MIL-C-50652/12(MU)
AMENDMENT 1
7 June 1973

MILITARY SPECIFICATION

CIRCUIT CARD ASSEMBLY: 10548086

(INTEGRATOR, RATE)

FIGURE 1A △R OUTPUT SIGNALS

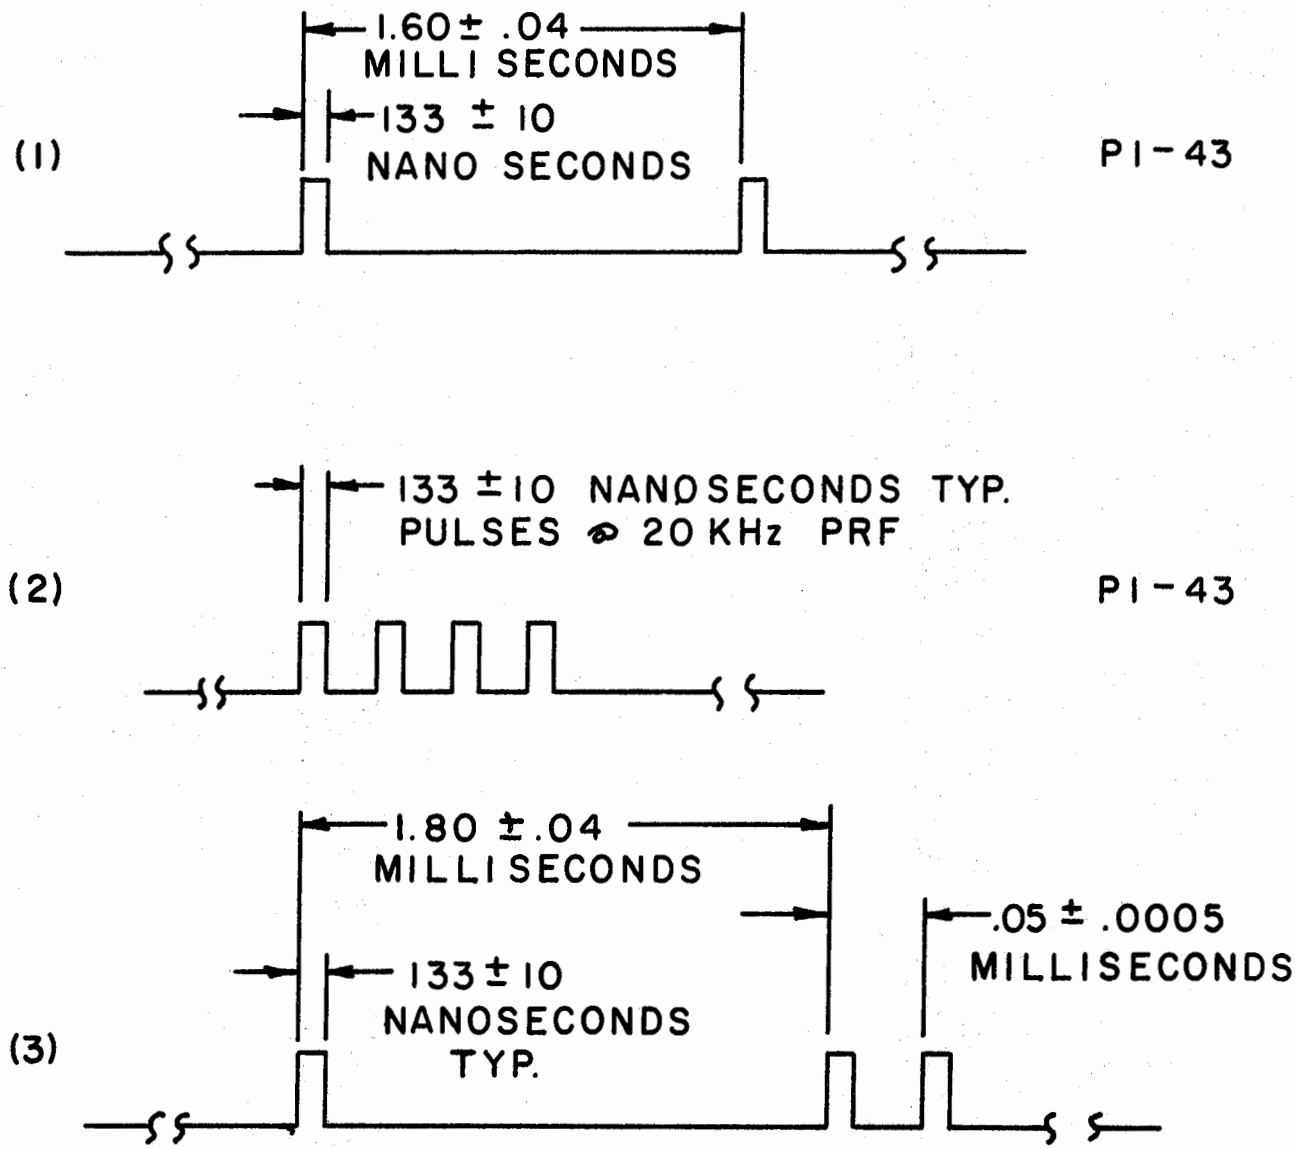
Following Figure 1, add new Figure 1 A.
